SUBJECT: MINIMUM CRITICAL POWER RATIO LIMITS (TAC NO. 65348)

Re: HOPE CREEK GENERATING STATION

AMENDMENT TO FACILITY OPERATING LICENSE

Amendment No. 9
License No. NPF-57

MINIMUM CRITICAL POWER RATIO (MCPR)
VERSUS TAU AT RATED FLOW
Figure 3.2.3-1

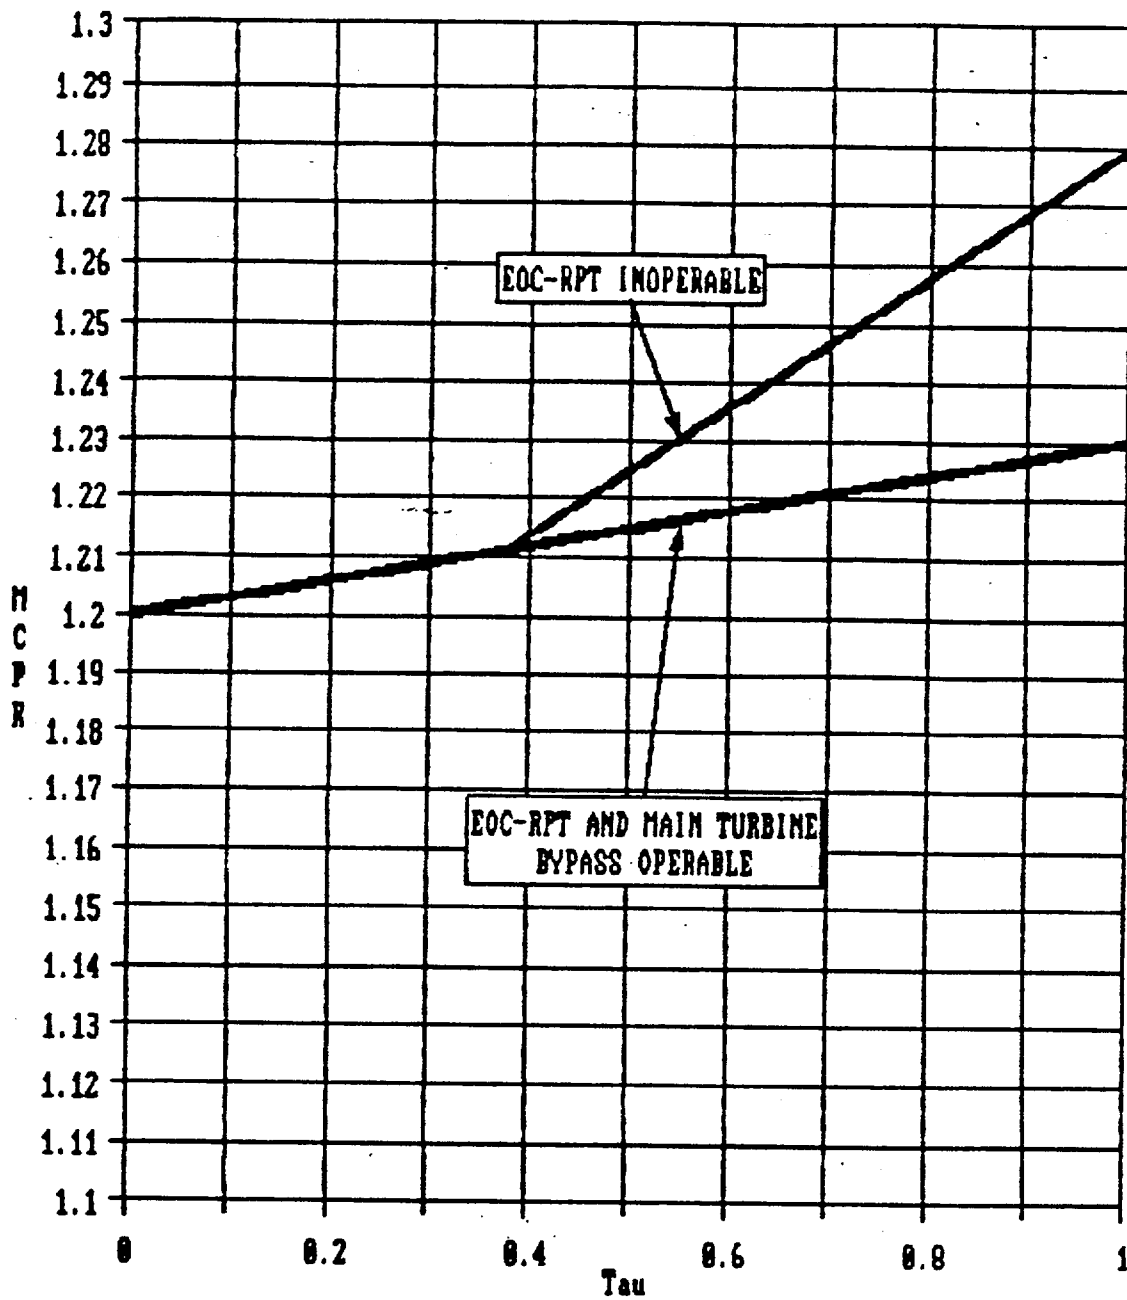
This amendment increases the minimum critical power ratio limits provided in Technical Specification Figure 3.2.3-1 for operable end-of-cycle recirculation pump trip and main turbine bypass systems.

Replace the following page of the Appendix "A" Technical Specifications with the attached page. The revised page is identified by Amendment number and contains vertical lines indicating the area of change.

The licensee-proposed changes to increase the MCPR limits to reflect the measured recirculation flow coastdown will allow operation of the reactor without declaring the EOC-RPT system inoperable.

On the basis of the above discussion, the staff concludes that the proposed changes to the MCPR limits are acceptable.
